**City of Sweet Home**

**Staff Report Presented to the Planning Commission**

**FILE NUMBER:** SD22-02

**PROJECT:**  
**CLEAR WATER SUBDIVISION**

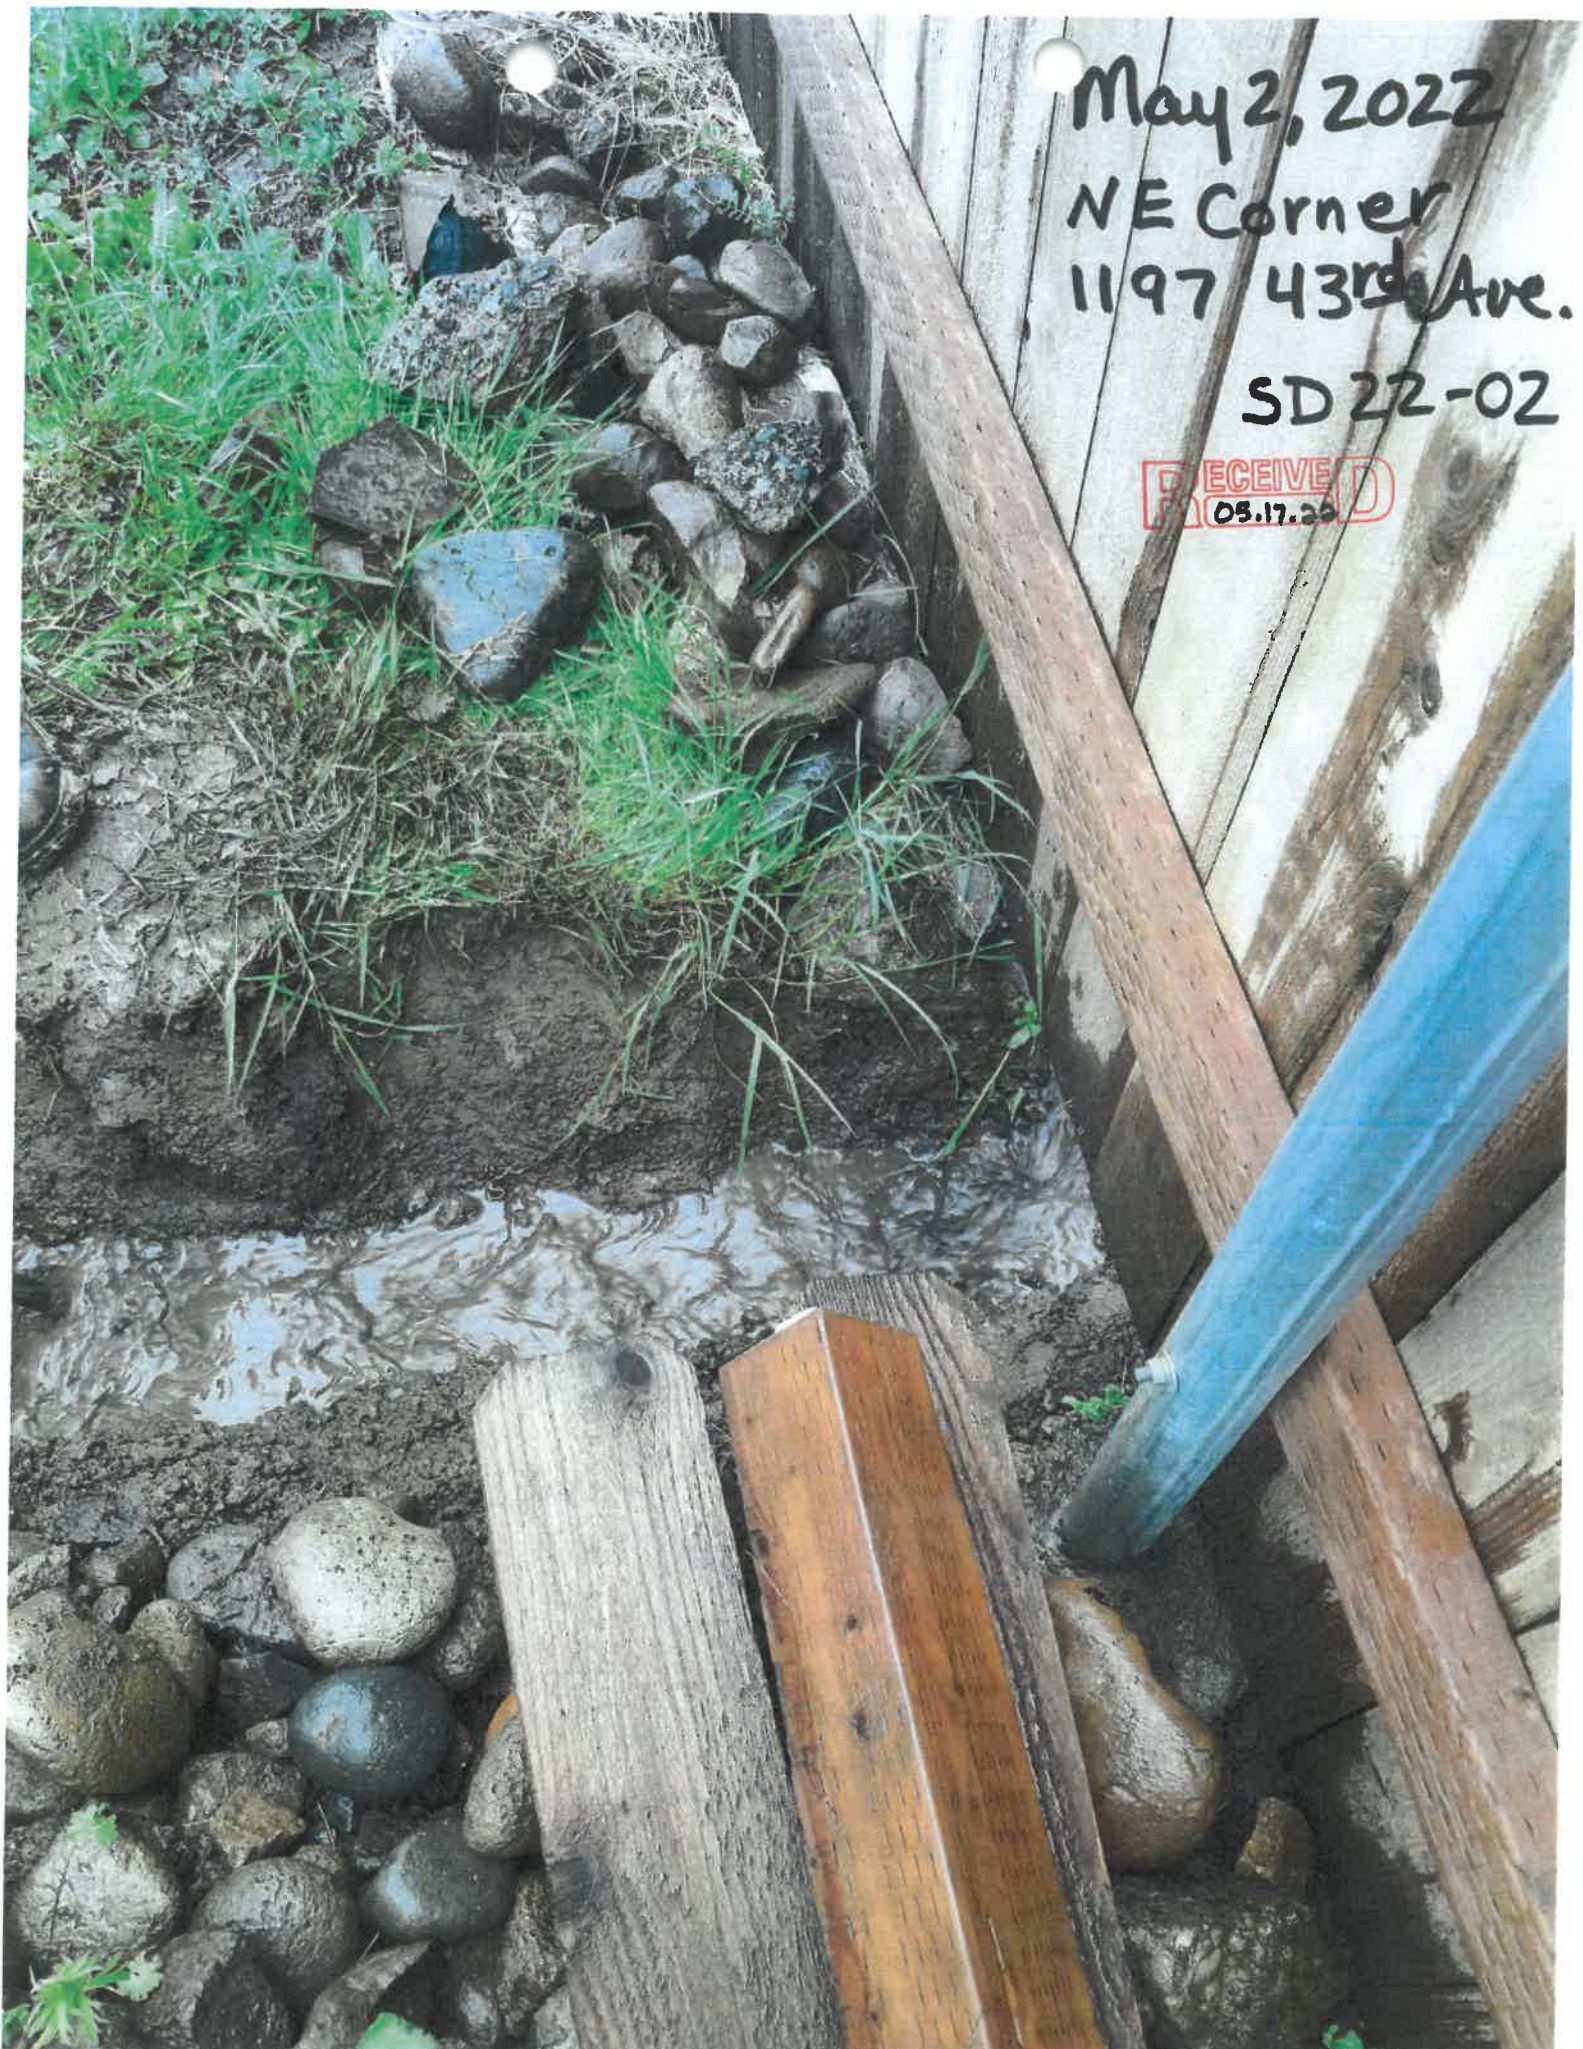
*I counter these statements. There is a drainage feature, on the West side of the subject property, which carries water during rain events. This rainfall accumulates and inundates adjacent and nearby tax lots as the elevation of the subject property is lowest in the northwest corner. I experience standing water on the north side and northeast corner of my property during heavy rain events from this accumulation.*
